STAFF RECOMMENDATION
1406 North 14th Street
January 20, 2021

Application: New Construction – Addition; Setback Determination
District: Eastwood Neighborhood Conservation Zoning Overlay
Council District: 06
Map and Parcel Number: 07214017400
Applicant: Andrew Rhodes
Project Lead: jenny.warren@nashville.gov

<p>Description of Project: Application to construct an addition to a contributing house.</p> <p>Recommendation Summary: Staff recommends approval of the proposed addition with the conditions:</p> <ol style="list-style-type: none">1. Staff approve the foundation material, roofing color, side stair and railing materials, rear patio material, windows and doors prior to purchase and installation; and2. HVAC will be located on the rear façade, or on a side façade past the midpoint of the house. <p>With these conditions, Staff finds that the project meets Section II.B.2 for additions and Section III.B.2 for appropriate demolition of the design guidelines for the Eastwood Neighborhood Conservation Zoning Overlay.</p>	<p>Attachments A: Photographs B: Site Plan C: Elevations</p>
--	--

Figure 2. Historic house in blue, addition in orange.

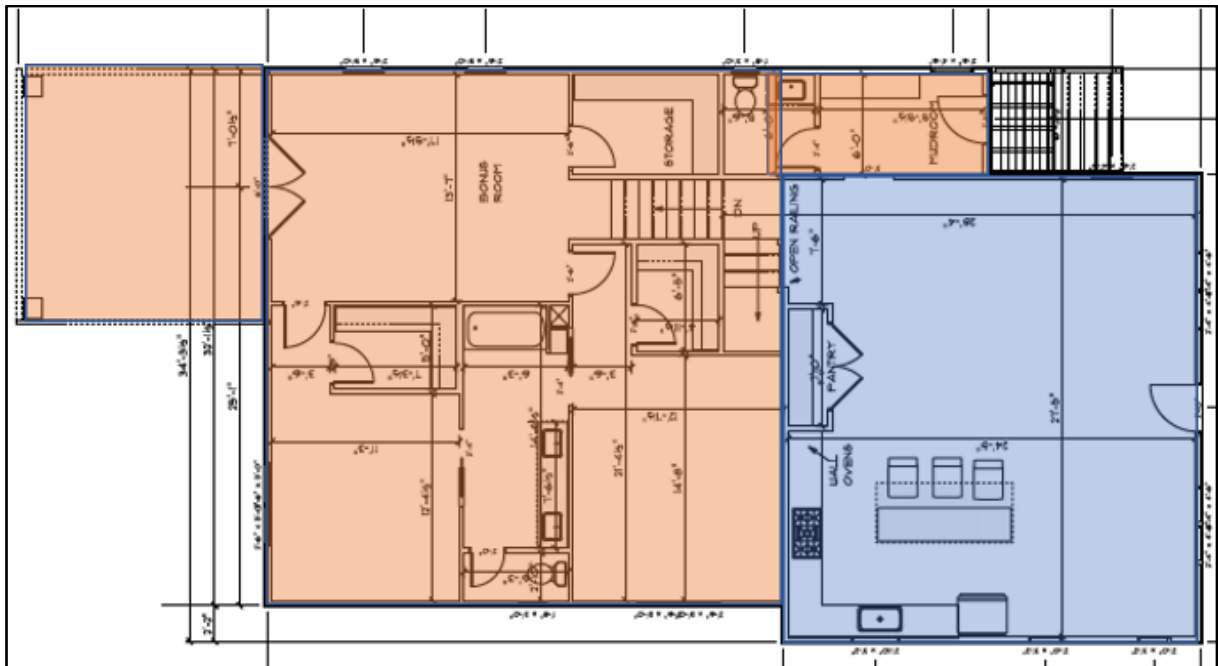
In terms of height, the proposed addition is appropriate. It will step no higher than the historic house. The house is only one story, but the addition will take advantage of the sloping grade and will have two stories. The second story will tie into the historic roof just below the side gabled ridge line and will not be taller than the existing house.

As proposed, the addition includes a side addition which continues back to become a rear addition that is wider than the historic house. This addition wraps the back corner of the house.

Figure 4. Site plan

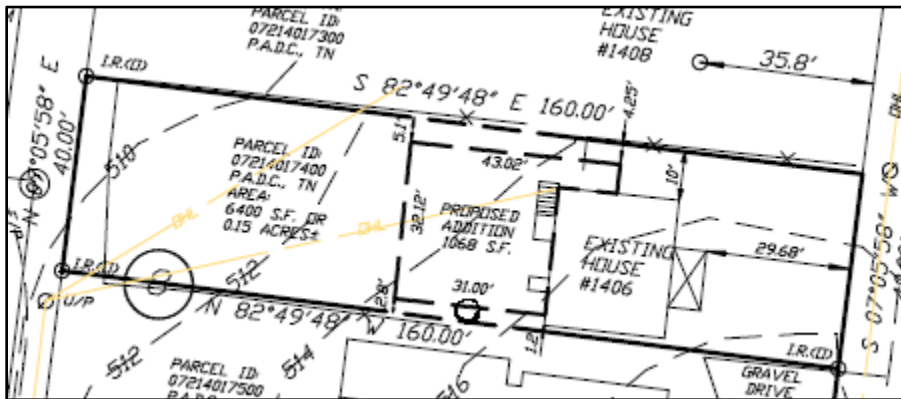
Setback: As proposed, the addition will require a setback determination on both sides.

The lot is particularly narrow at forty feet (40') wide. Additionally, the house is shifted to one side, and also sits at a slight angle on the lot, rather than having side walls parallel to the property lines. On the left side, the rear corner of the historic house is just over one foot (1') from the side property line. The addition will be inset from the side wall by two feet, two inches (2'2") on this side, but will still be within the five foot (5') side setback. Staff finds that this encroachment could be appropriate, as it does not come any closer to the side property line than the existing house.

On the right side, the new addition will be five feet (5') from the property line at the rear, but because the house sits at a slight angle on the lot, the addition will be four feet, three inches (4'3") from the property line at the front, rather than the required five feet (5'). Staff finds that an encroachment of nine inches (9") could be appropriate due to the narrow lot and angled siting.

The addition will not change the front setback and will be about sixty-eight feet (68') from the rear property line. The project meets section II.B.1.c.

Figure 5. Right side elevation.

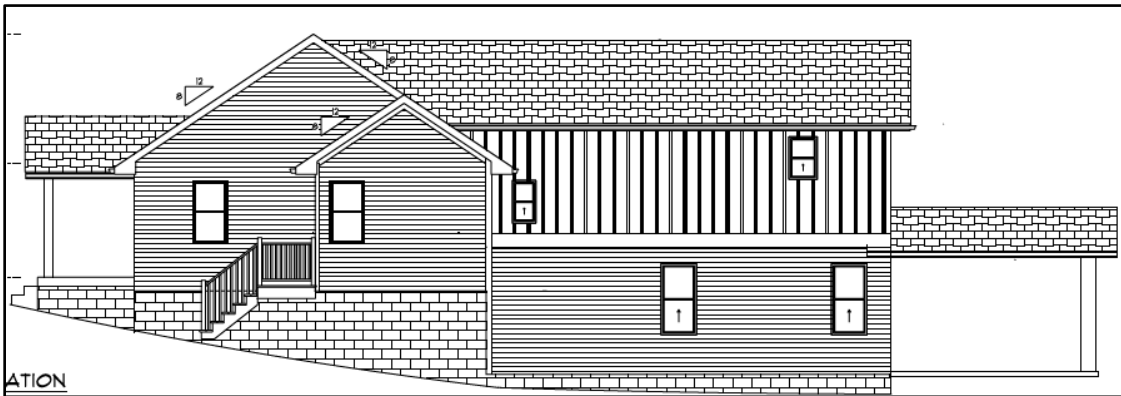
Roof form: The roof is gabled with 4/12 pitch. The side addition has a side-gabled roof with an 8/12 pitch that matches the main roof. (Figure 5) The proposed roof form is compatible, and the project meets section II.B.1.e.

Figure 6. Left elevation. Arrow indicates window to be re-introduced, as seen in photo.

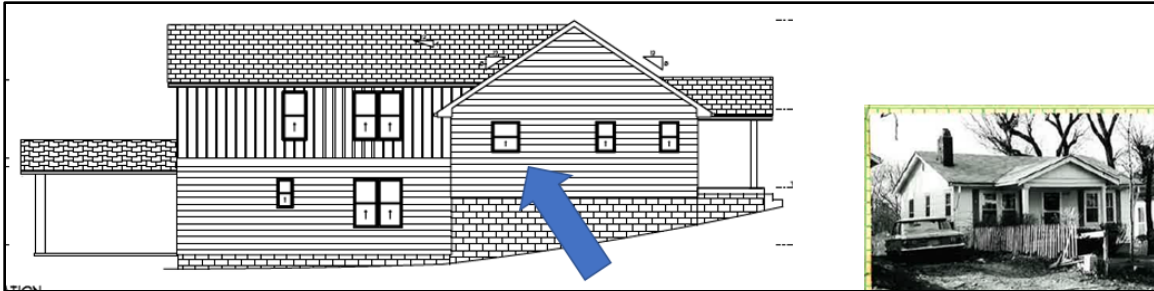
Proportion and Rhythm of Openings: The windows on the proposed addition are generally twice as tall as they are wide, meeting the proportion of historic openings. There is one square window on the rear elevation, but staff finds that this could be appropriate, due to its location on the rear. There are no long expanses of wall space without a window or door opening. One change is proposed to the historic structure: a window will be added near the back of the left elevation on the historic part of the house. There is no window there today, but one shows on a photograph of the house from the 1960s. Staff finds the project’s proportion and rhythm of openings to meet Section II.B.1.g.
